Access Compliance Report

Public Rights-of-Way

Intersection ID: 9810	Main Street: BRIDGEPORT_DR	Cross Street: THE_PLAZA	Location:	N
ADA ID: 05F8E9E336DB	Ramp Type: Perp	Initial Pass/Fail: Fail	Overall Compliance: No	Severity Score: 37.5
Codes/Mitigation Info/Possible Solution		Field Measurements/Component Compliance

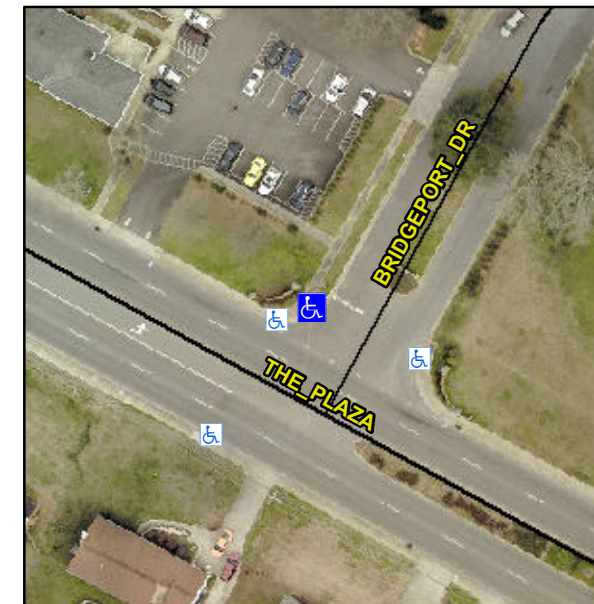
R304.2.2, R304.5.3

Compliance	Description	Data	Compliance	Description	Data
N/A	Ramp Length (in)	60.0	No	Ramp Slope (%)	9.1
Yes	Ramp Width (in)	48.0	No	Ramp XSlope (%)	7.6
N/A	Flare Type LT	N/A	N/A	Flare Type RT	N/A
N/A	Flare Slope LT (%)	N/A	N/A	Flare Slope RT (%)	N/A
N/A	Flare Traversable LT?	N/A	N/A	Flare Traversable RT?	N/A
N/A	Landing Length (in)	N/A	N/A	DWS Provided?	N/A
N/A	Landing Width (in)	N/A	N/A	DWS Contrast?	N/A
N/A	Landing Slope (%)	N/A	N/A	DWS Length (in)	N/A
N/A	Landing X Slope (%)	N/A	N/A	DWS Full Width?	N/A
N/A	Landing Curb? (Y/N)	N/A	N/A	DWS Offset (in)	N/A
N/A	Shared Landing?	N/A			
N/A	Gutter Ponding?	N/A	N/A	Gutter Slope (%)	N/A
N/A	Gutter Lip Ht (in)	N/A	N/A	Gutter X Slope (%)	N/A
N/A	Painted X Walk1?	No	N/A	Painted X Walk2?	N/A
	X Walk 1 Direction	To SE		X Walk 2 Direction	N/A
N/A	X Walk 1 Width (in)	N/A	N/A	X Walk 2 Width (in)	N/A
	X Walk 1 Slope (%)	2.9		X Walk 2 Slope (%)	N/A
	X Walk 1 X Slope (%)	4.1		X Walk 2 X Slope (%)	N/A

Remove & Replace Entire Ramp.
